Access Compliance Report

Public Rights-of-Way

Intersection ID: 49895	Main Street: FERRELL_COMMONS_RD	Cross Street: PROSPERITY_COMMONS_DR	Location: E
ADA ID: 10F9A87ED386	Ramp Type: Perp	Initial Pass/Fail: Pass	Overall Compliance: No
Severity Score: 0.25			
Codes/Mitigation Info/Possible Solution		Field Measurements/Component Compliance

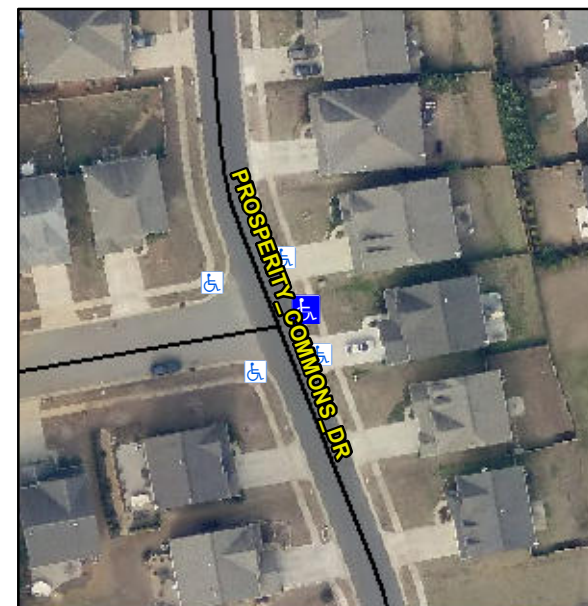
Not Found, R304.5.3, R304.2.2-Perp, R304.3.2-Para

Compliance	Description	Data	Compliance	Description	Data
N/A	Ramp Length (in)	70.5	Yes	Ramp Slope (%)	5.4
Yes	Ramp Width (in)	48.0	No	Ramp XSlope (%)	2.4
N/A	Flare Type LT	Sloped	N/A	Flare Type RT	N/A
N/A	Flare Slope LT (%)	3.4	Yes	Flare Slope RT (%)	6.8
N/A	Flare Traversable LT?	Yes	N/A	Flare Traversable RT?	Yes
Yes	Landing Length (in)	48.0	Yes	DWS Provided?	Yes
Yes	Landing Width (in)	48.0	Yes	DWS Contrast?	Yes
No	Landing Slope (%)	3.1	Yes	DWS Length (in)	24.5
No	Landing X Slope (%)	2.5	Yes	DWS Full Width?	Yes
N/A	Landing Curb? (Y/N)	No	Yes	DWS Offset (in)	1.0
N/A	Shared Landing?	Yes			
Yes	Gutter Ponding?	No	Yes	Gutter Slope (%)	1.3
Yes	Gutter Lip Ht (in)	0.0	Yes	Gutter X Slope (%)	0.9
N/A	Painted X Walk1?	No	N/A	Painted X Walk2?	N/A
	X Walk 1 Direction	To W		X Walk 2 Direction	N/A
N/A	X Walk 1 Width (in)	N/A	N/A	X Walk 2 Width (in)	N/A
	X Walk 1 Slope (%)	1.6		X Walk 2 Slope (%)	N/A
	X Walk 1 X Slope (%)	1.2		X Walk 2 X Slope (%)	N/A

Remove & Replace Entire Ramp.
